# **Olympic Peninsula Transmission Line Reinforcement Project**

**Revision Sheet for the Environmental Assessment  
Finding of No Significant Impact**

**DOE/EA-1576**  
Bonneville Power Administration

**Revision Sheet**  
**for the**  
**Olympic Peninsula Transmission Line Reinforcement Project**  
**Final Environmental Assessment**  
DOE/EA -1576

Figure 15

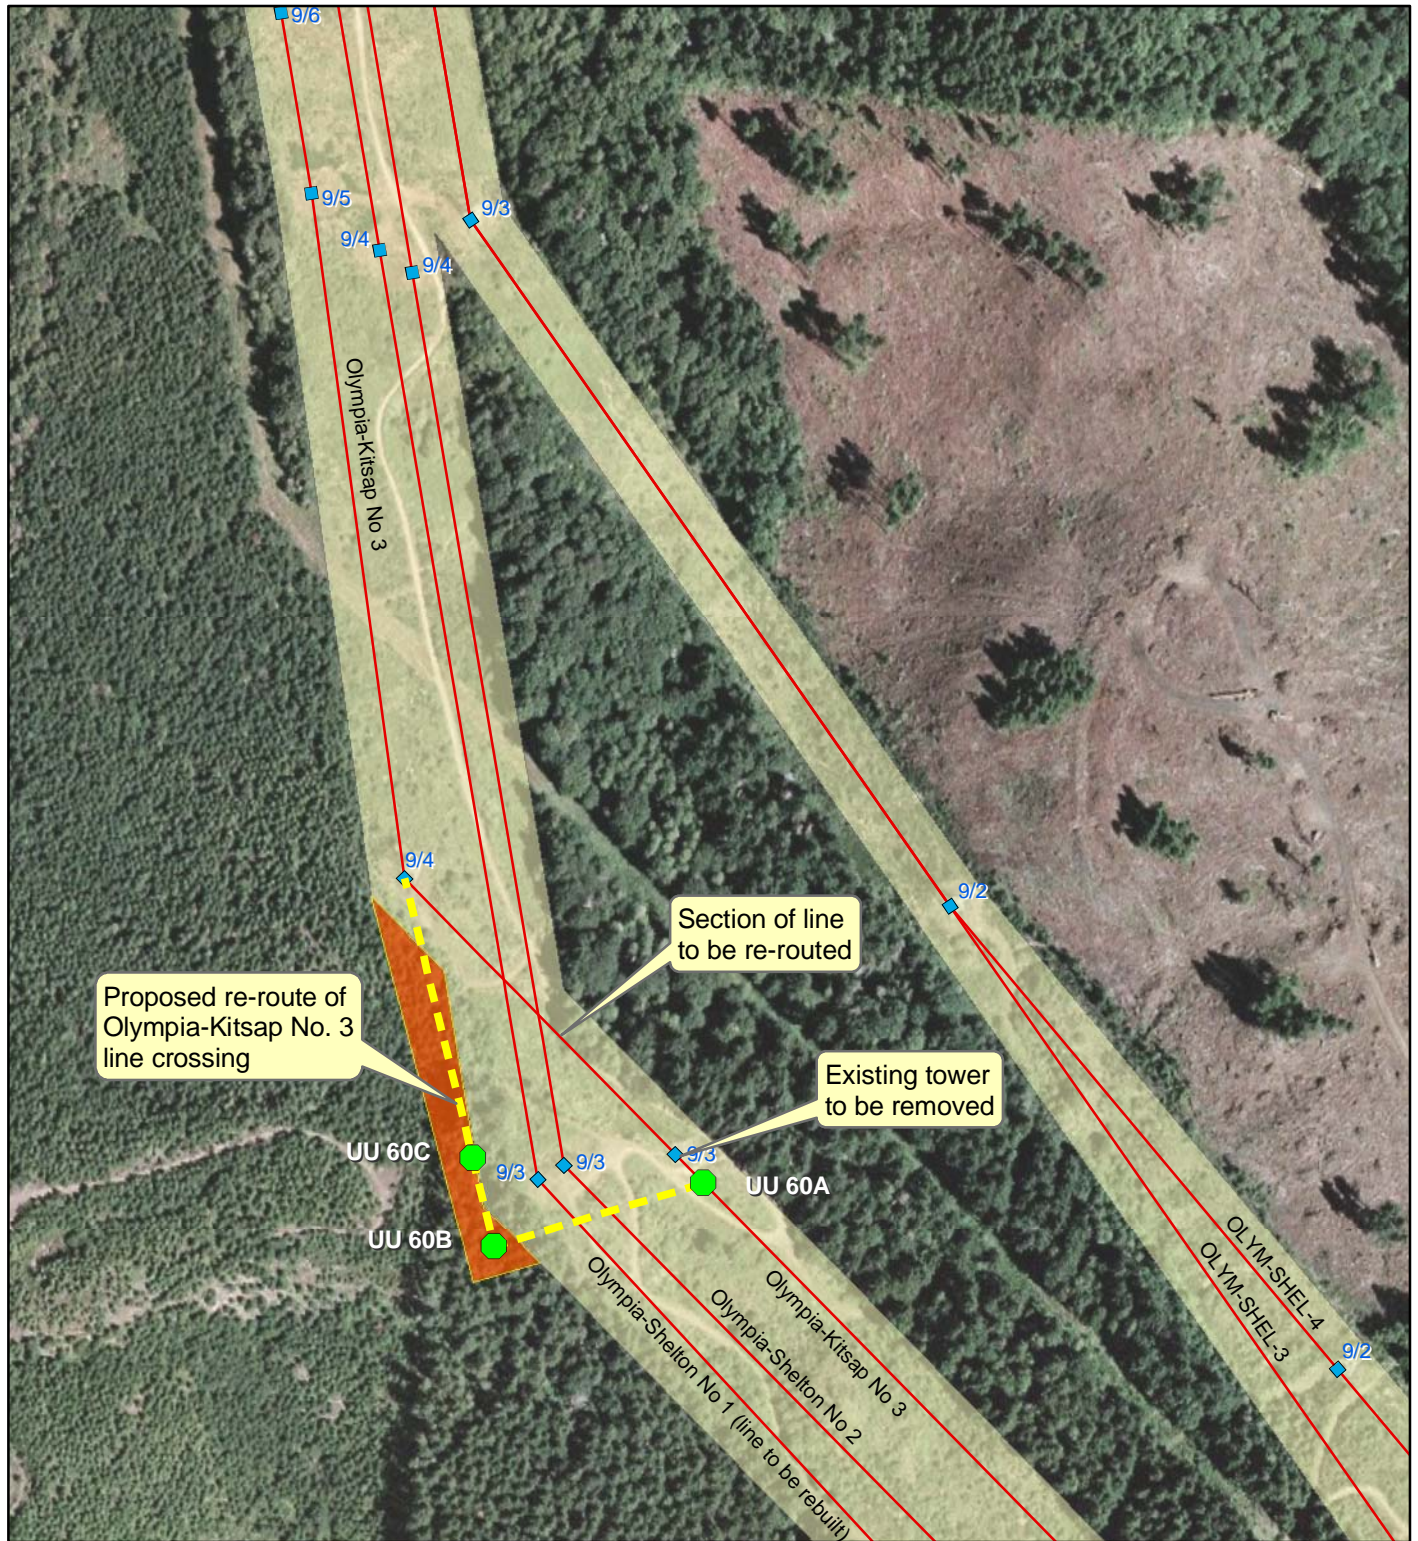
Please note that there has been a change in Mile 9 of the right-of-way which requires three additional new towers. Also, two towers that were proposed in wetlands in miles 11 and 12 have been moved out of wetlands. These changes to the Proposed Action necessitated changes in the text and the addition of Figure 15.

The first mile of the Olympia-Kitsap No. 3 230-kV line (H-Frame and *lattice steel* structures and conductor) would also be removed. This would be completed after this line is rerouted. In addition, one tower in Mile 9 of this line would be removed (see Section 2.1.4 and Figures 2 and 15).

In Mile 9, the Olympia-Kitsap No. 3 line crosses over the existing Olympia-Shelton No. 1 line. Removing then rebuilding the Olympia-Shelton No. 1 line would require some changes on the Olympia-Kitsap No. 3 line. To avoid placing new structures on steep slopes, one existing tower on the Olympia-Kitsap No. 3 line would be removed, and one new lattice steel structure and two new H-Frame wood pole structures would be built on terrain less steep (see Figure 15). This change would require about 1.5 acres of new ROW on the west side of the transmission line corridor (see Figure 15).

In three locations, BPA would need to acquire additional ROW. In Mile 9, two new structures would be needed on new, permanent ROW (see Section 2.1.4 and Figure 15). About 1.5 acres of new ROW would be required.
